DeKalb County Department of Planning & Sustainability

STAFF ANALYSIS

Case No.:	Z-23-1246456	Agenda #: 2023-0585
Address:	4750 Flat Shoals Parkway in Decatur, Georgia.	Commission District: 03 Super District: 07
Parcel ID(s):	15-068-01-066	
Request:	Rezoning from NS (Neighborhood Shopping) Zoning District to MU-1 (Mixed Use-1) Zoning District to allow a mixed-use building with residential and commercial uses.	
Property Owner(s):	The Hudson Holding Company	
Applicant/Agent:	Devon Hudson	
Acreage:	1.37	
Existing Land Use:	Vacant	
Surrounding Properties:	Commercial and Restaurant uses	
Adjacent Zoning:	North: NS South: NS East: NS West: NS	
Comprehensive Plan:	Commercial Redevelopment Corridor Consistent <input checked="" type="checkbox"/> Inconsistent <input type="checkbox"/>	
Proposed Density: 3 du/acre	Existing Density: NA

Z1.00

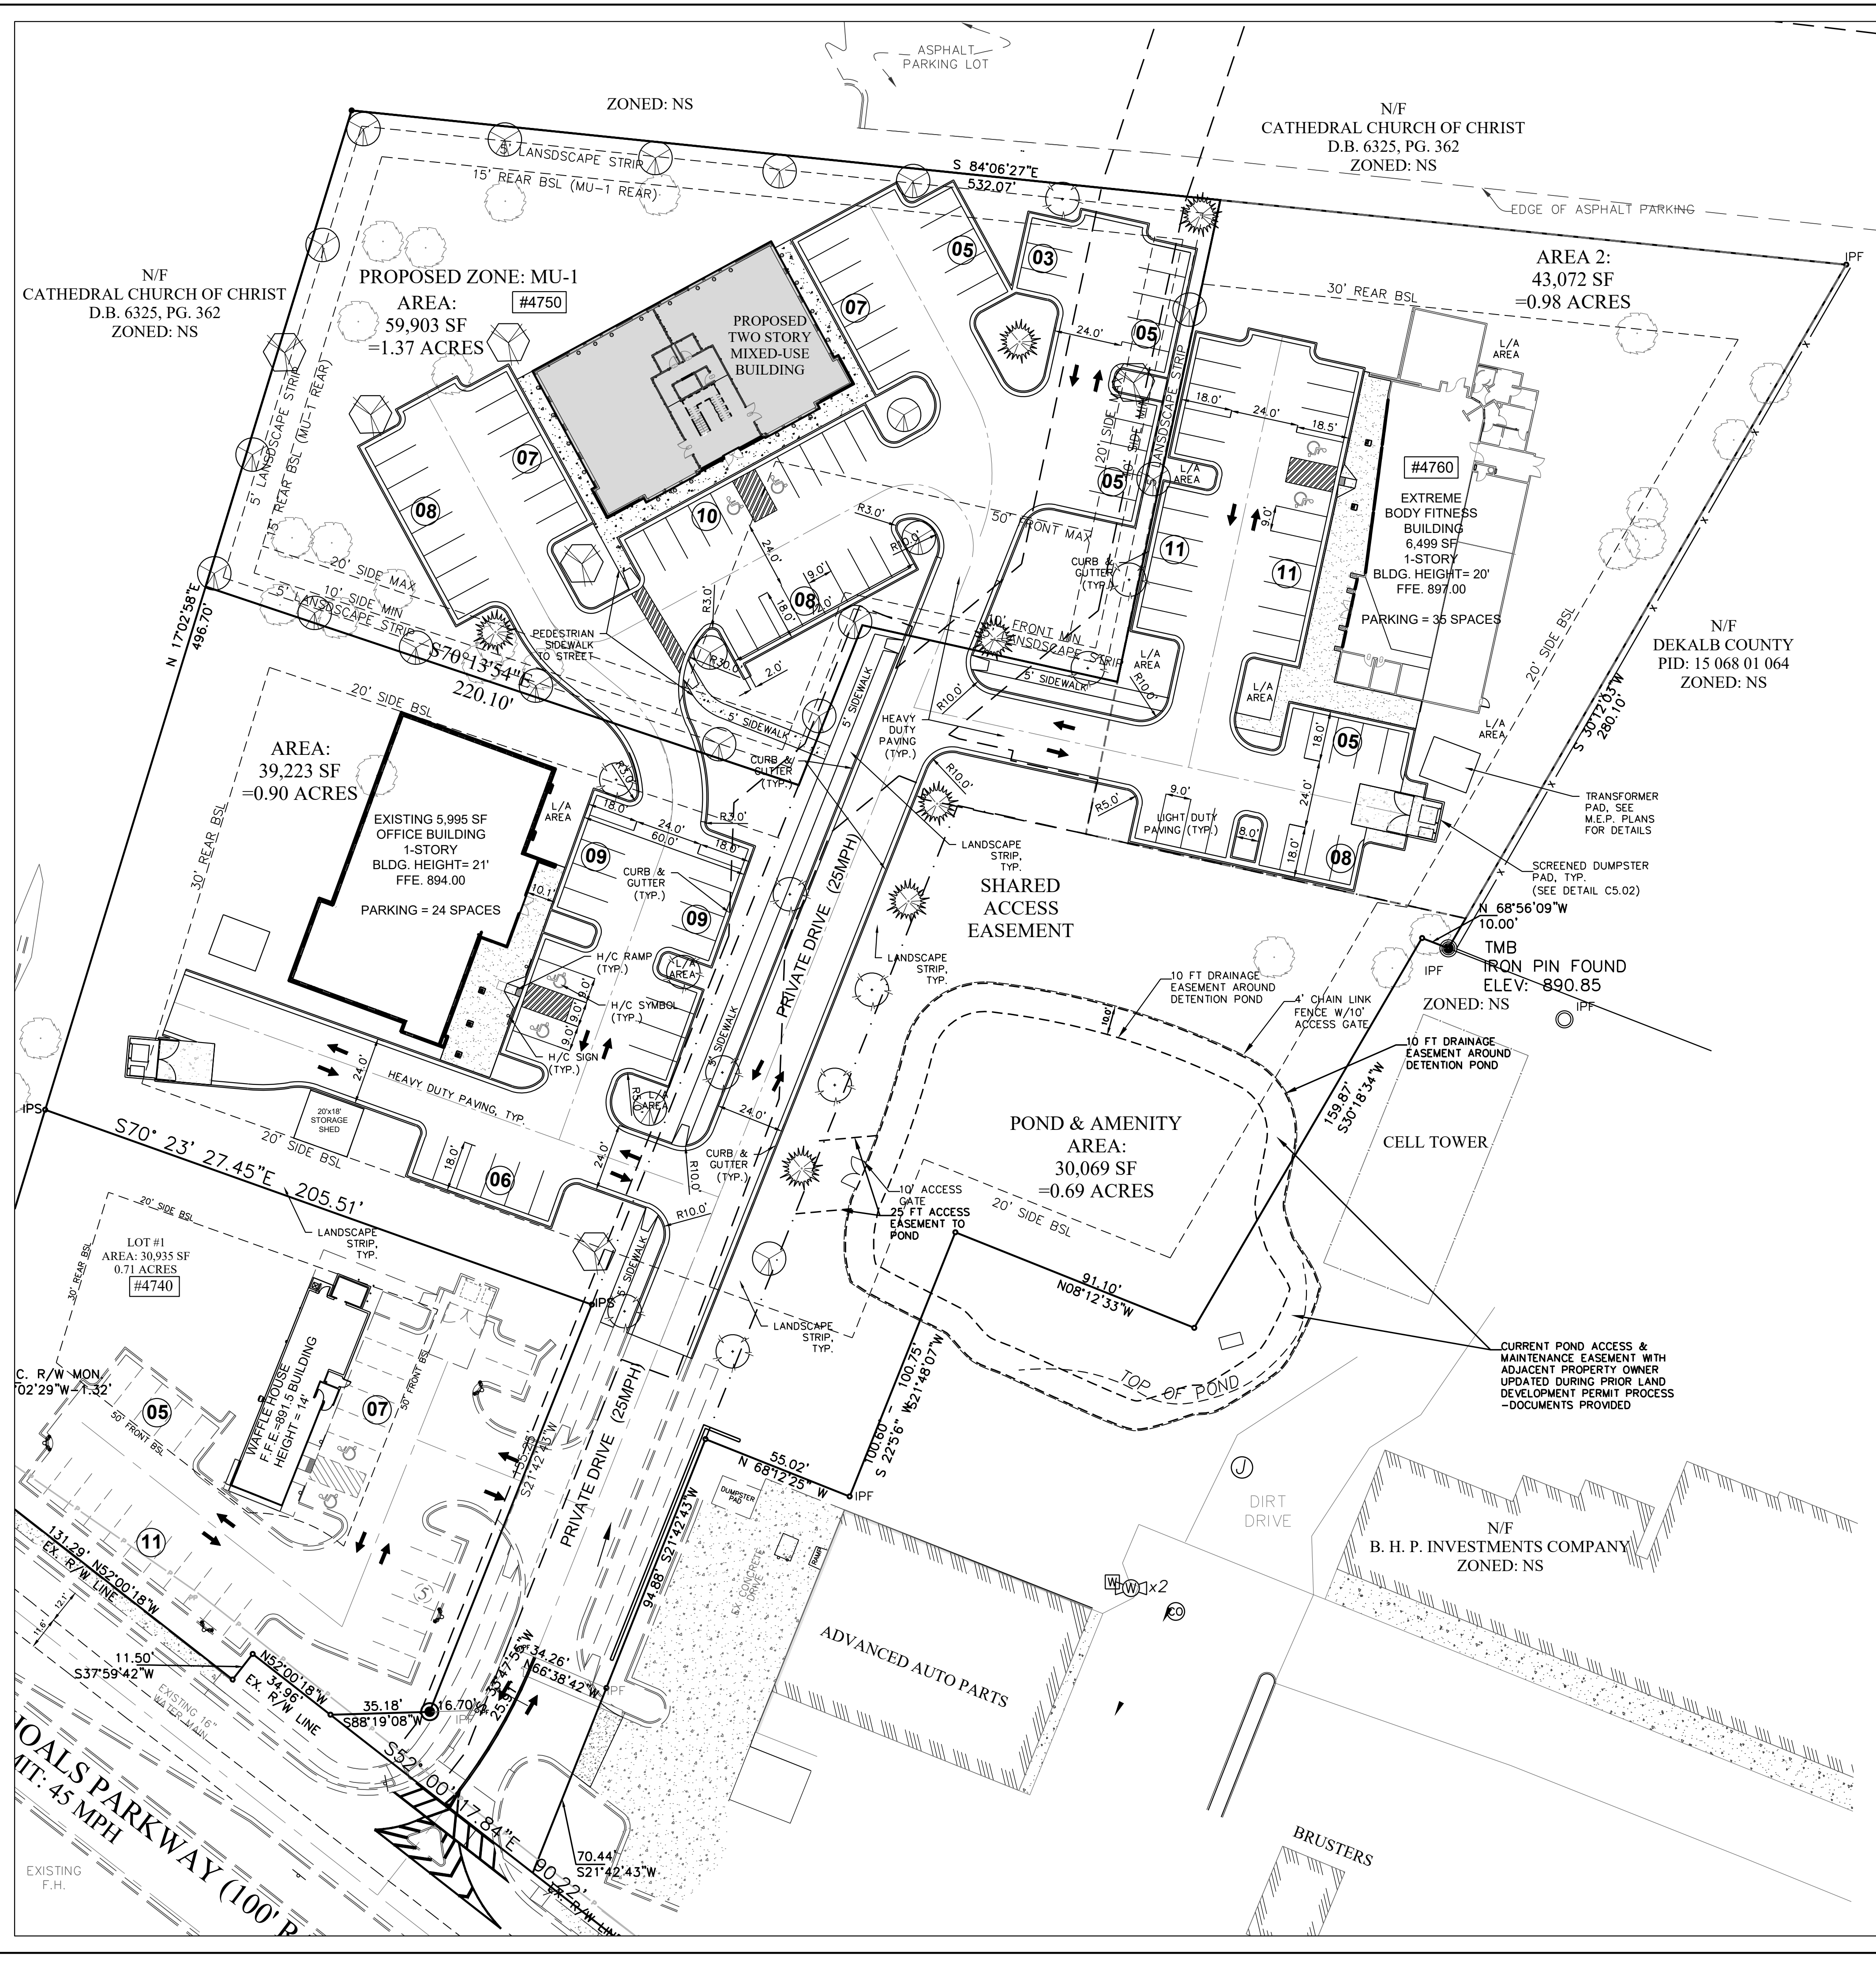
Based on the submitted site plan, several variances would appear to be required including but not limited to the following:

1. A 10-foot-wide landscape strip is required along the Flat Shoals Parkway right-of-way with one street tree for every 50 feet of street frontage;
2. A 6-foot-wide landscape strip with street trees for every 50 feet of frontage is required along the private street frontage (revised plan shows a 5-foot-wide landscape strip); and
3. Maximum side yard setback allowed by MU-1 district is 20 feet, proposed concept plan shows a 30-foot-wide building setback.

1. The subject property shall be developed in a manner generally consistent with the site plan dated 08/01/2023 titled “The Water Towers” prepared by Edwards Engineering Consultants. The Site Plan is conceptual and should there be any conflicts between the Site Plan and the *Zoning Ordinance*, the *Zoning Ordinance* shall prevail.
